## **ENVIRONMENTAL COMMISSION MEETING MINUTES**

### **Wednesday, September 21, 2016**

b. **Name:** Austin Oaks Planned Unit Development, C814-2014-0120

**Request:** Review and consider for recommendation the environmental aspects of the proposed PUD, including code modifications and environmental superiority

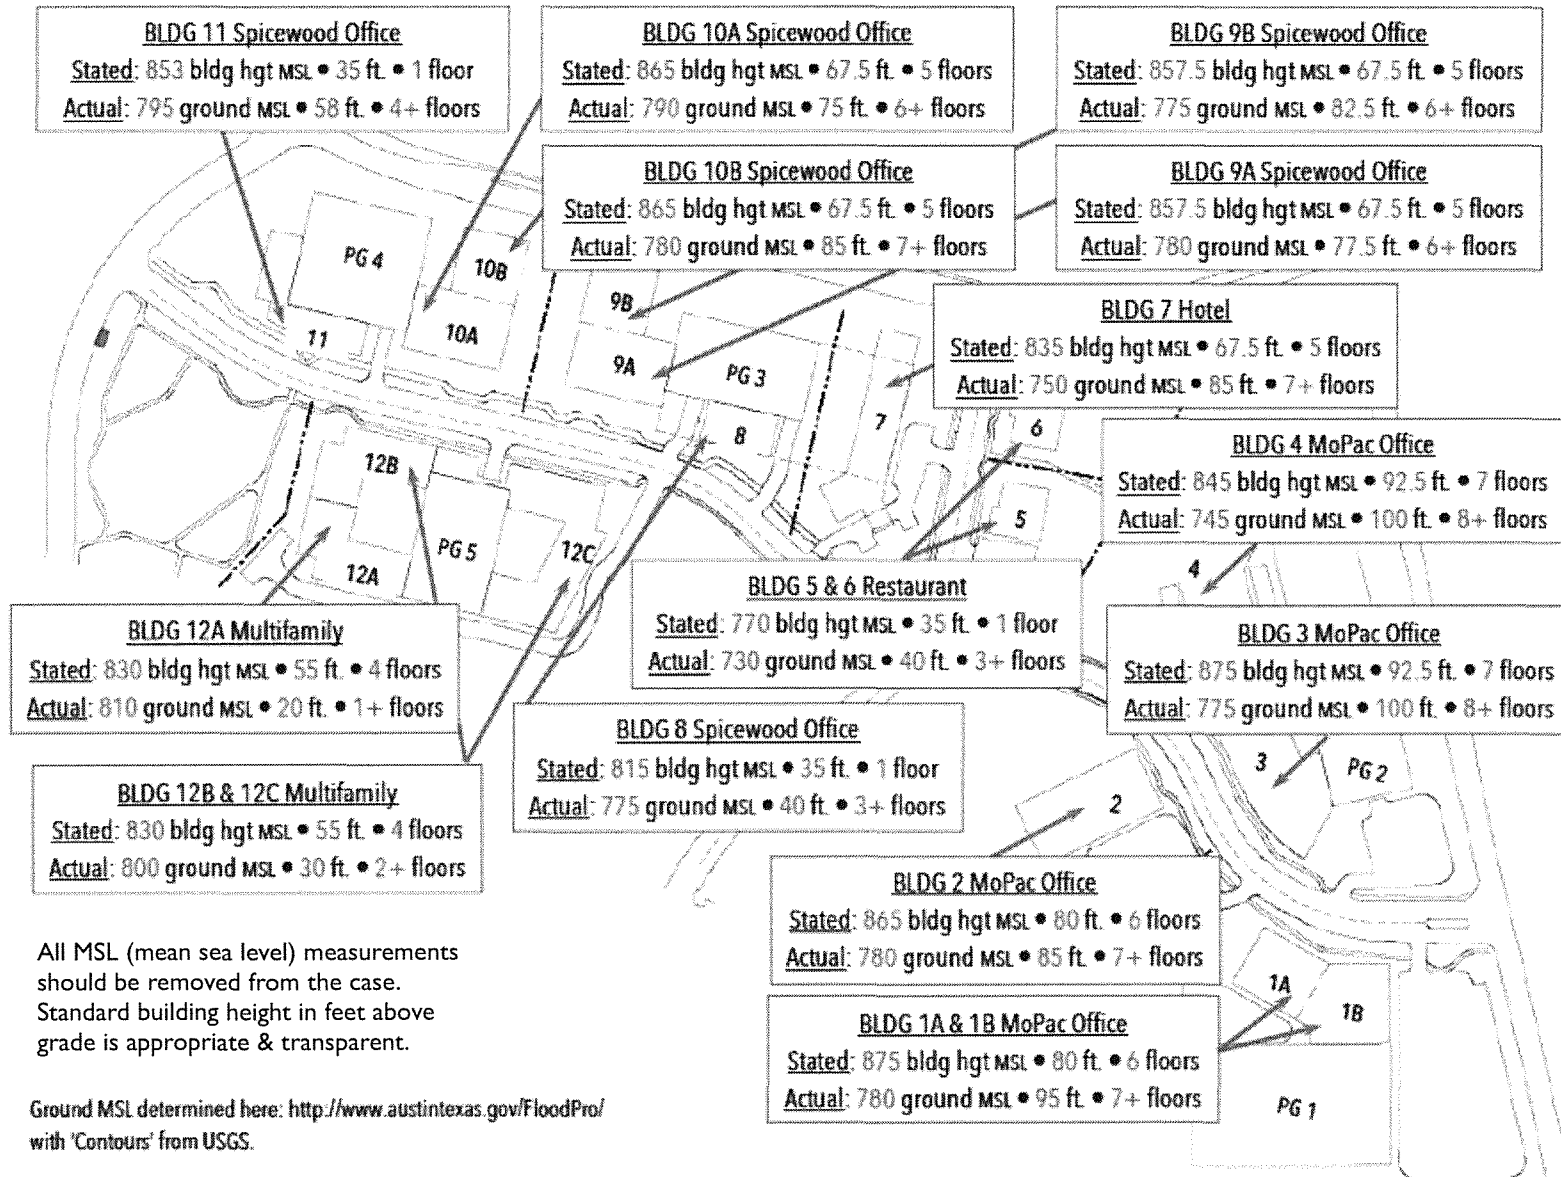
It has been verified that at least 4 of the 31 Protected Trees requested to be cut down in the 2013 Survey now objectively measure 24 inches in diameter, should be Heritage Trees and evaluated appropriately (#2118, #1081, #1074, #975). Pics of the trees. TRY TO EVALUATE TO TRANSPLANT OR DESIGN AROUND AT LEAST 4 ADDITIONAL OF THE PARTICULARLY IMPRESSIVE PROTECTED/HERITAGE TREES (INCLUDING #1028, #2219, #1097, #1009).

Lastly, the applicant includes 7 x +30" healthy trees in their request to cut down under the proposed PUD, WITHOUT REVIEW. EC SHOULD REQUIRE THAT ALL 30" OR GREATER TREES HAVE TO CONTINUE TO GO THROUGH THE ESTABLISHED REVIEW PROCESS IF EVENTUALLY ARE REQUESTED TO BE REMOVED. (It is our belief that most of those can be cost effectively designed around.)
